**Subject:****GRINDING NOISE FROM CLUTCH PEDAL WHEN DEPRESSING****Bulletin No:** 05-003/16**Last Issued:** 02/10/2016**APPLICABLE MODEL(S)/VINS**

2016 MX-5 vehicles with VINs lower than JM1ND\*\*\*\*\*104047 (produced before August 7, 2015)

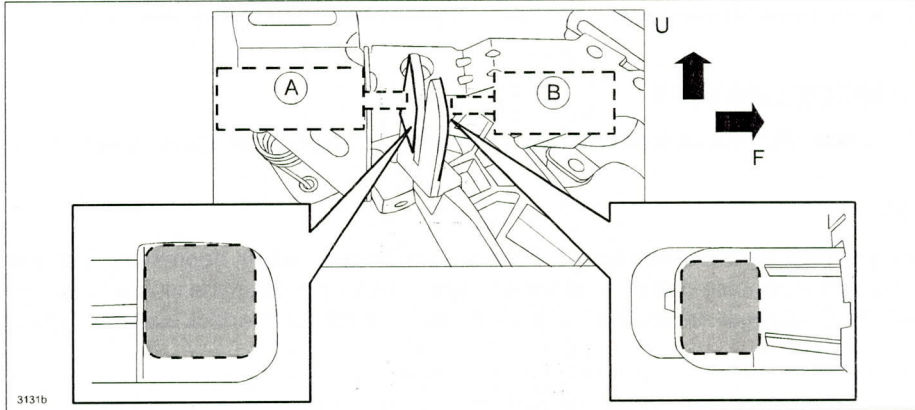
Some vehicles may exhibit a grind noise from around the clutch pedal when depressing it all the way down. This is caused by a stick-slip noise occurring at the contact point (A) between the clutch pedal (B) and the clutch pedal position switch (C) plunger and/or the clutch pedal and the starter interlock switch (D) plunger (F: Vehicle front).

To prevent the stick-slip noise from occurring, two pieces of silicon pad have been attached to the clutch pedal where the two switches contact.

CLUTCH PEDAL POSITION SWITCH side

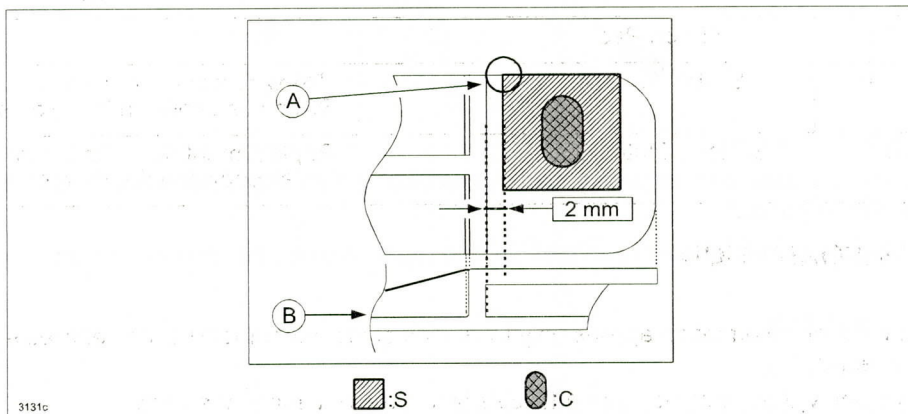
- c. Peel off the protective foil and apply the silicon pad to the clutch pedal as shown below (the clutch pedal position switch and the starter interlock switch sides).

A: Align one corner of the silicon pad with this point

C: Contact point of switch plunger

S: Silicon pad
